REGIONAL REVIEW NOTIFICATION

ARC REVIEW CODE: R1907021

Name of Proposal: The Exchange at Gwinnett (DRI 2945)

THE EXCHANGE AT GWINNETT DRI
Gwinnett County
Natural Resources Group Comments
June 28, 2019

SP-95

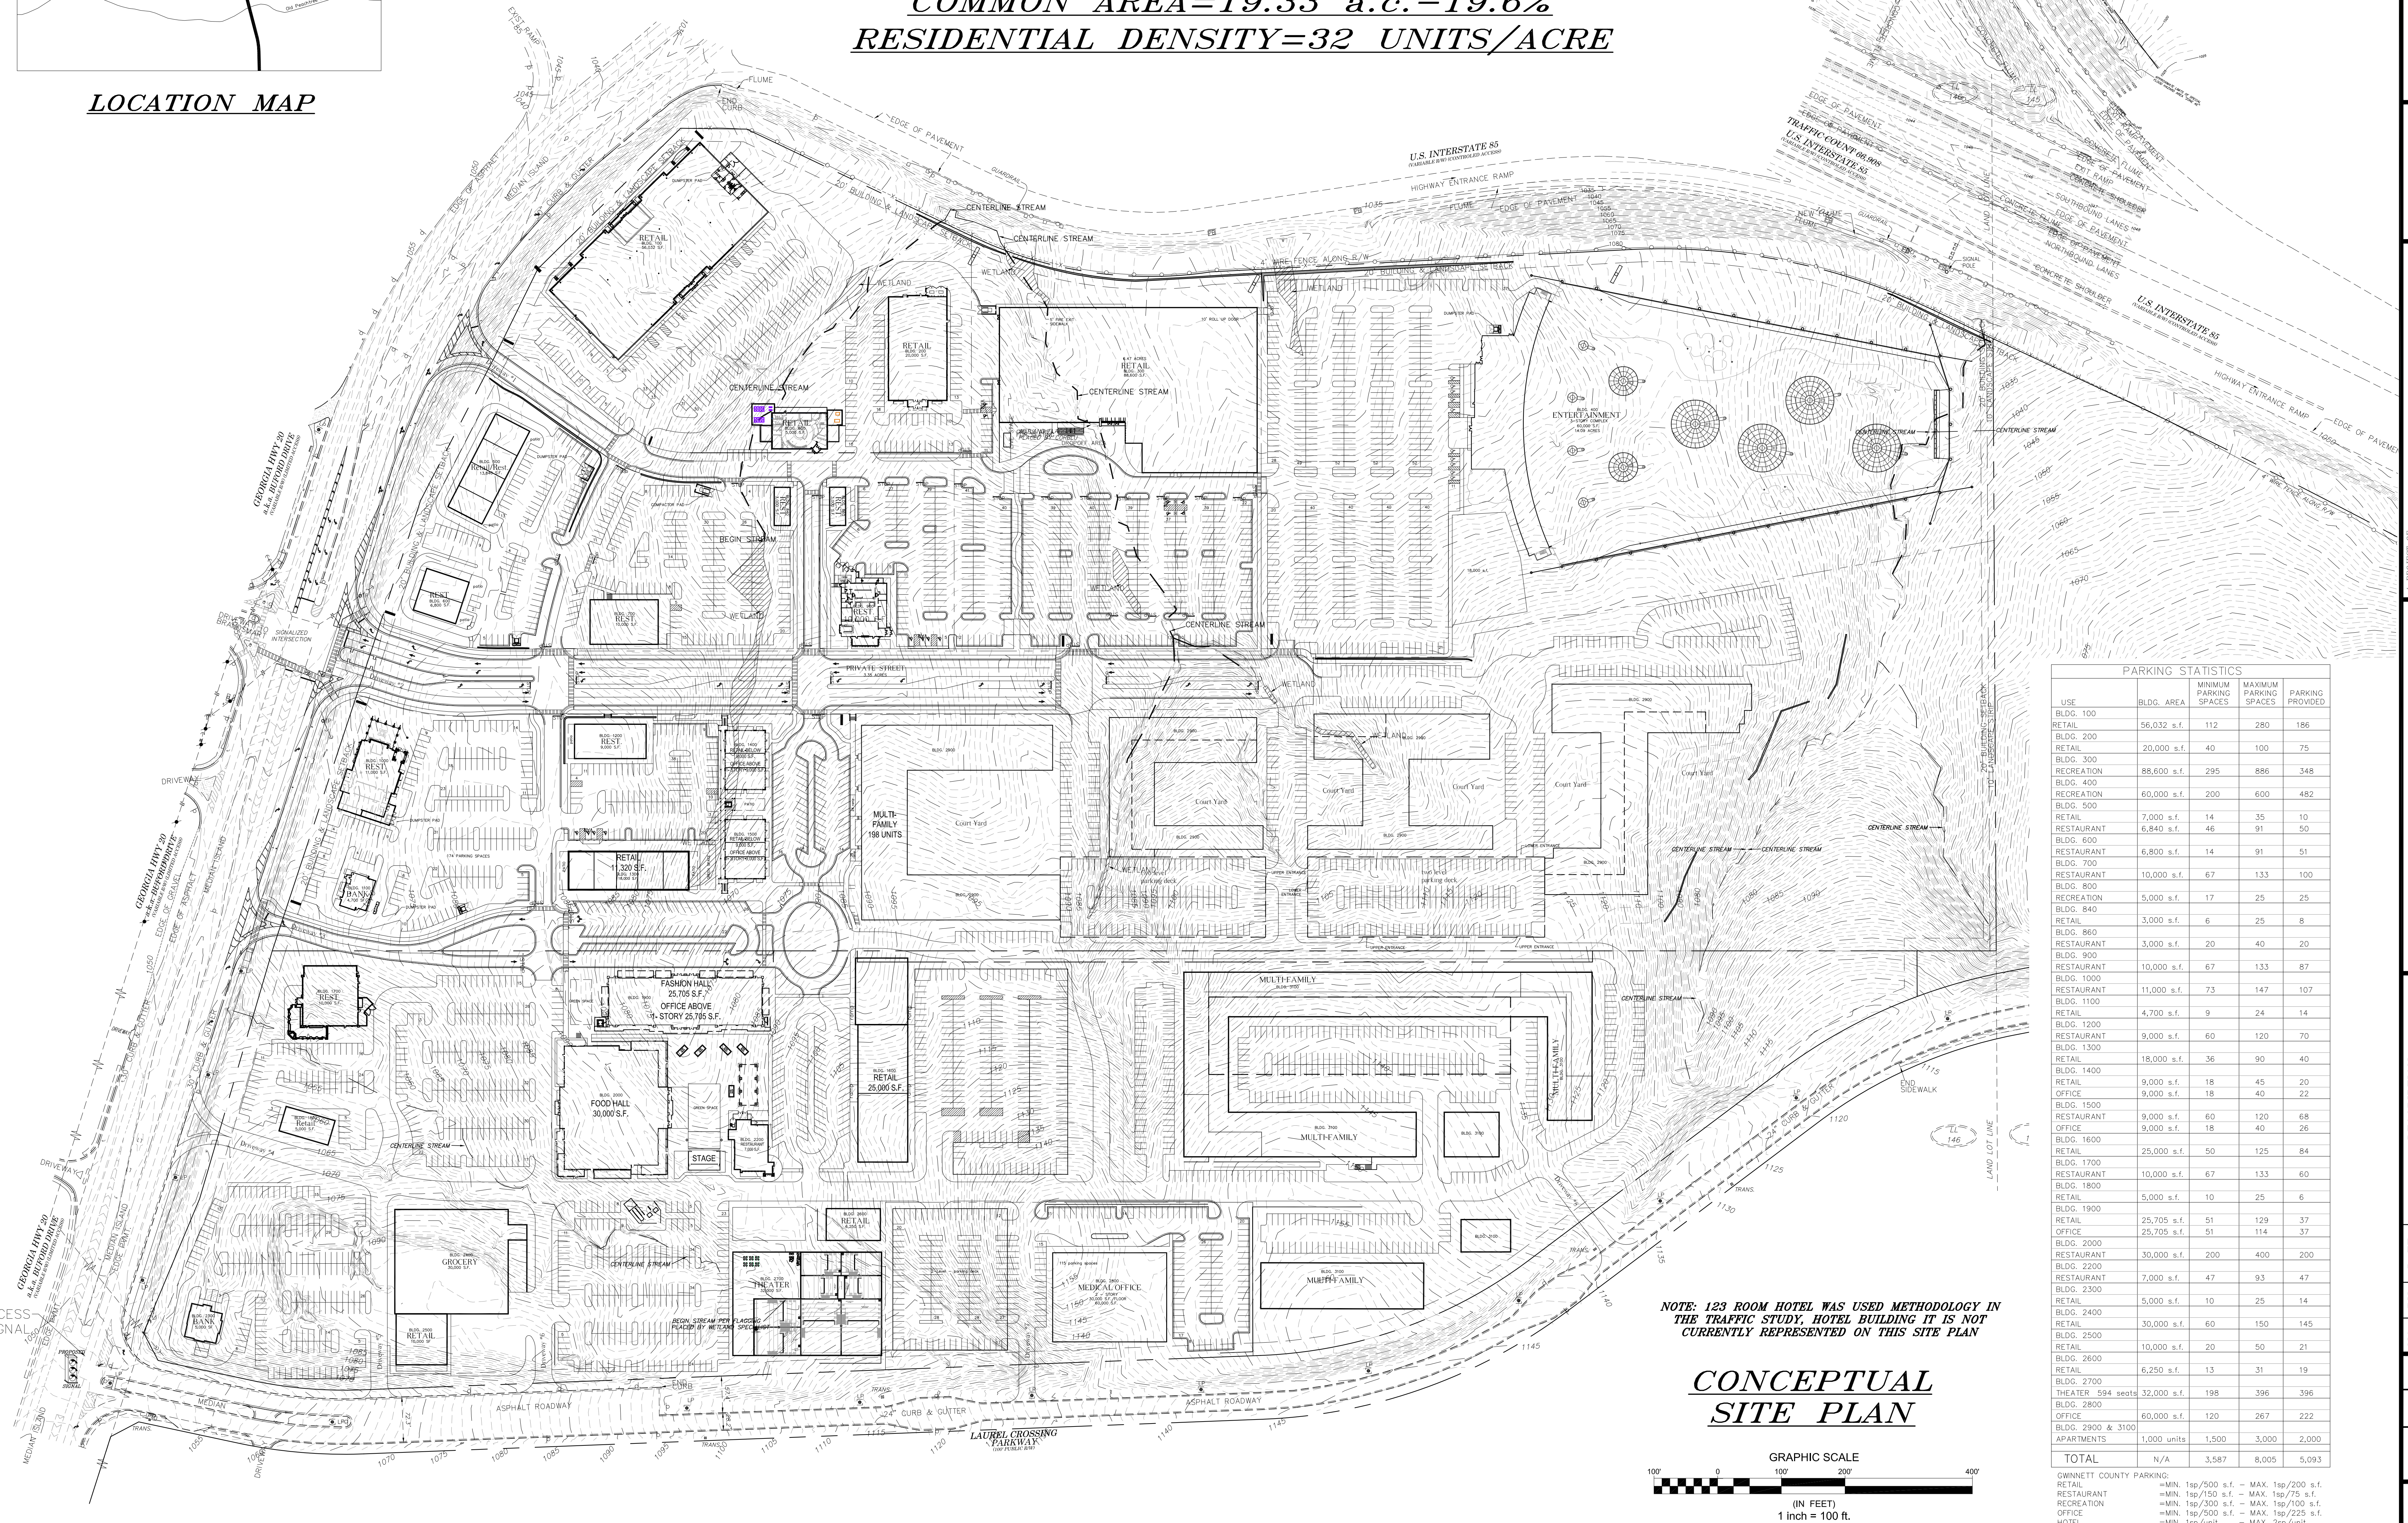
Both the submitted site plan and the USGS coverage for the project area show a tributary of Ivy Creek running north through the eastern portion of the project property. The submitted site plan also shows a branch of that tributary on the project property. The submitted site plan also shows two tributaries to Ivy Creek running through the central portion of the property. Ivy Creek is a tributary of Suwanee Creek, which flows to the Chattahoochee River. No buffers are shown along any of the streams. The site plan shows the proposed entertainment complex over a portion of the eastern tributary at the northeast corner of the site. Based on the submitted site plan, the majority of the central tributaries will be covered by buildings and roads. Identified wetlands associated with these streams are also affected. All streams on the property, including unmapped streams, are subject to the requirements of the Gwinnett County Stream Buffer, which include a 50-foot stream buffer and additional 25-foot impervious setback on most streams. All mapped or unmapped waters of the state on the property, including all streams, are also subject to the State 25-foot Sediment and Erosion Control buffer. All required buffers on the property should be shown on the site plan. Development activity within the County buffer or setback may require a variance from the County. Any activity in the State 25-foot Erosion and Sedimentation buffer may also require a variance.
